Addendum to the
Environmental Impact
Assessment Report

NISA
North Irish Sea Array

Marine Mammal Mitigation Protocol

Document no.	A14.5
Project/s	North Irish Sea Array (NISA) Offshore Wind Farm
Originator Company	North Irish Sea Array (NISA) Windfarm Limited
Document Type	PN- Plan, Management Plan
Package	ENV - Environmental
Revision	Addendum
Classification	N/A
Date	6/9/2026
Author	APEM Ltd/ GoBe/SMRUC

Appendix A: Pile driving mitigation procedure summary

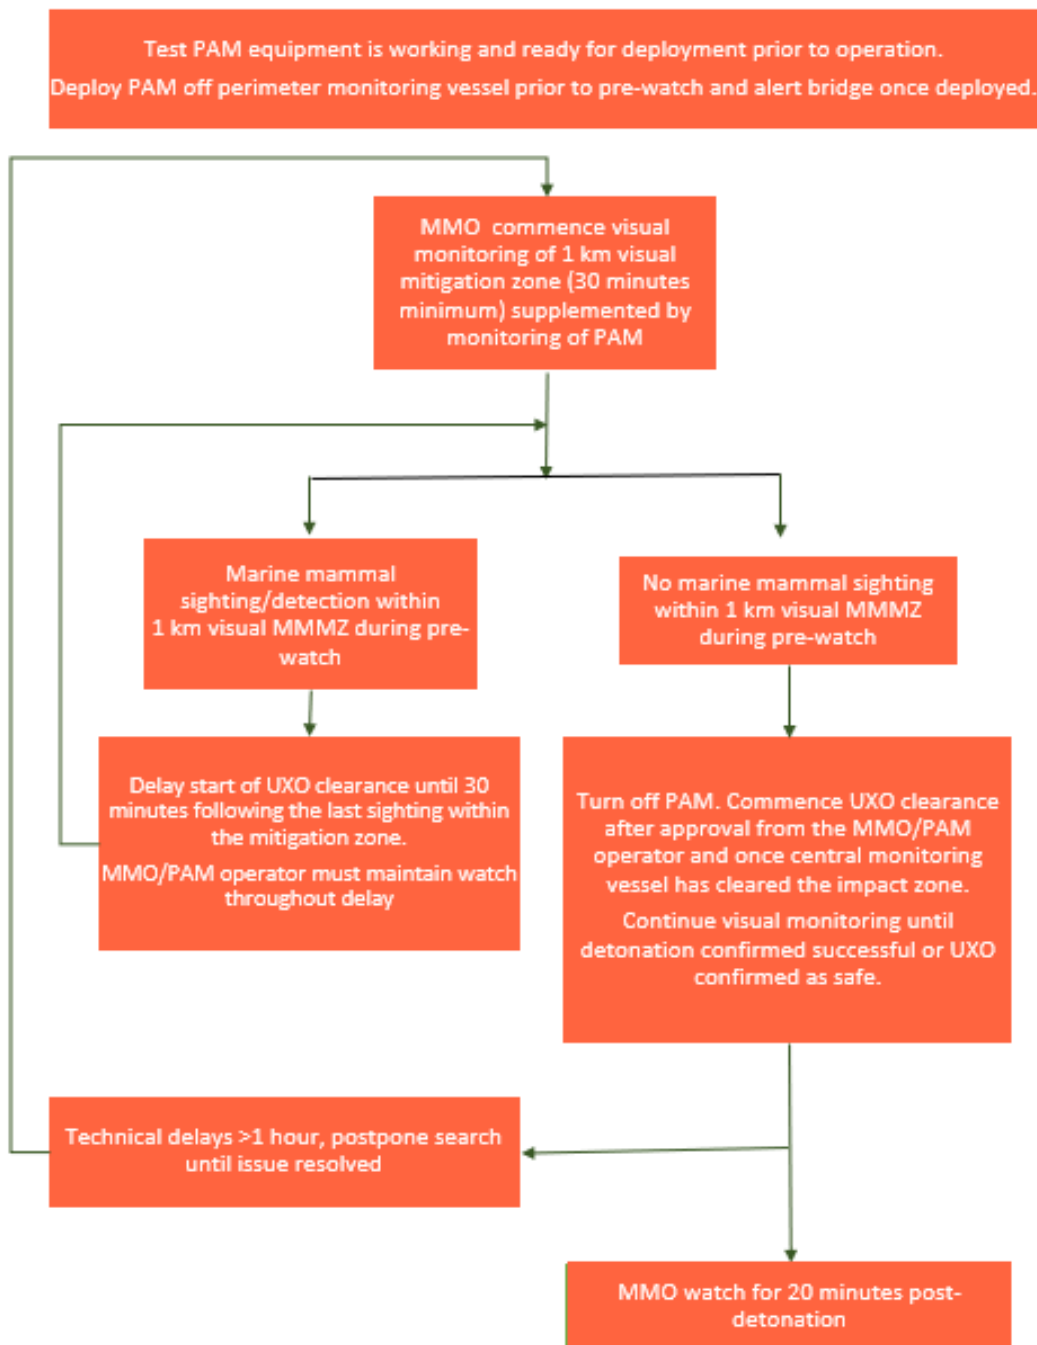
The change required in this section is in response to the refinement of the foundation installation types for Project Option 1 and Project Option 2 (refer to Appendix A5.1) with WTG jacket foundations being installed with suction buckets and OSP jacket foundations being installed with either drilled pin piles or suction buckets. Therefore, pile driving has been removed from the 2024 MMMP and Appendix A of the 2024 MMMP can be disregarded.

Appendix D: High-Order UXO mitigation procedure summary (replaces Appendix C in the 2024 MMMP). This procedure summary assumes the NAS is a bubble curtain (as an example). This will need to be modified for any other at-source noise reduction methods.

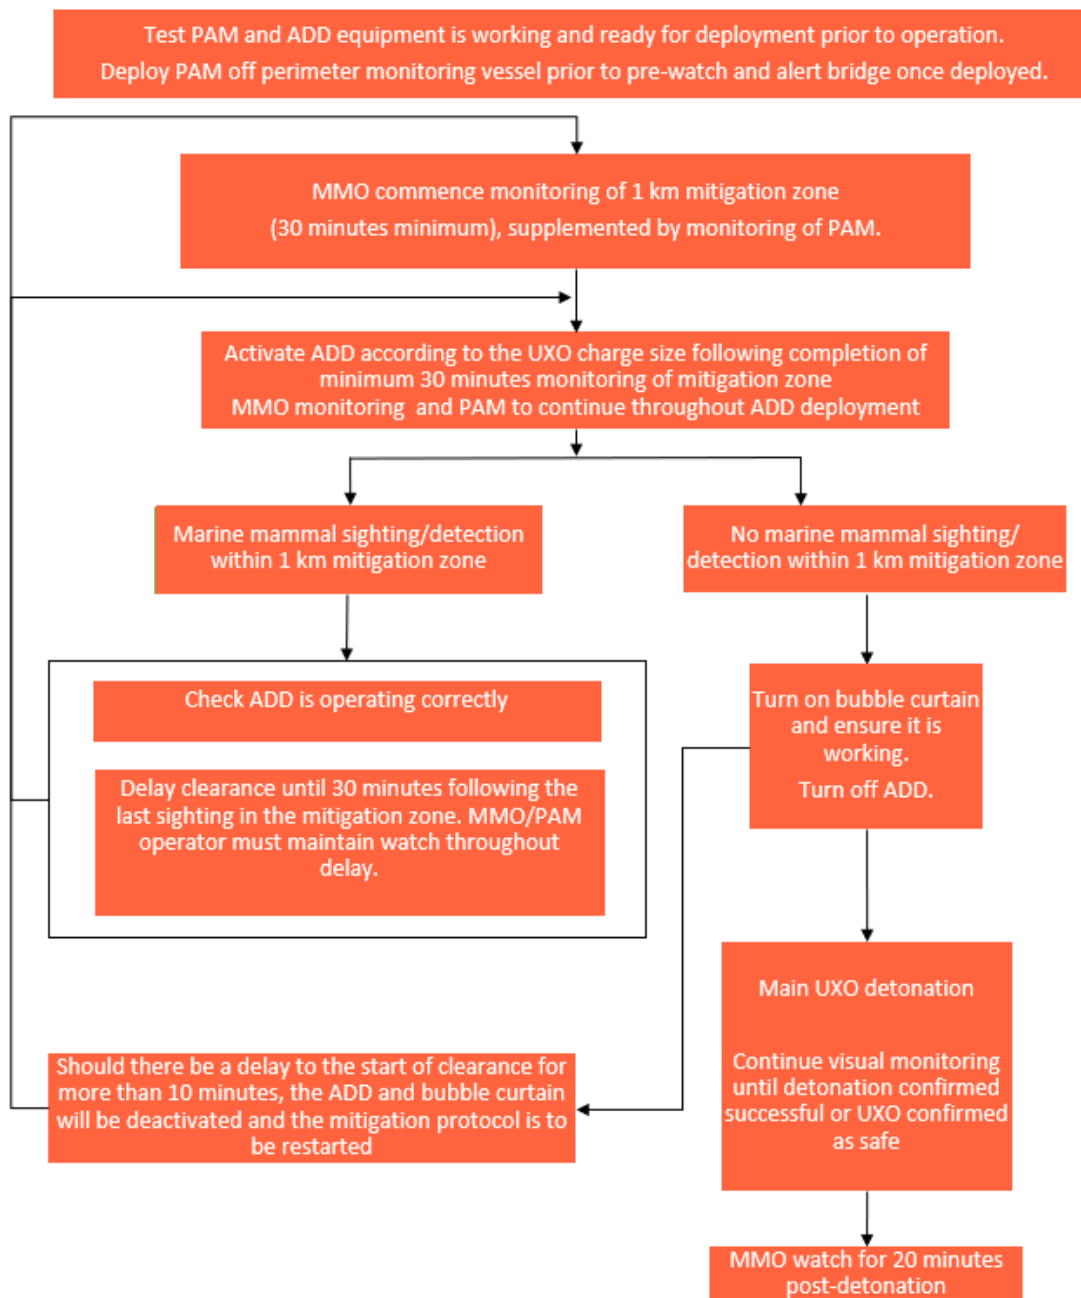
In response to RFI Section 10 (c), the key change for this section is the commitment from the Developer to use a NAS (e.g., bubble curtain) for any high-order clearance. Therefore, Appendix C of the 2024 MMMP shall be deleted and replaced with Appendix D.
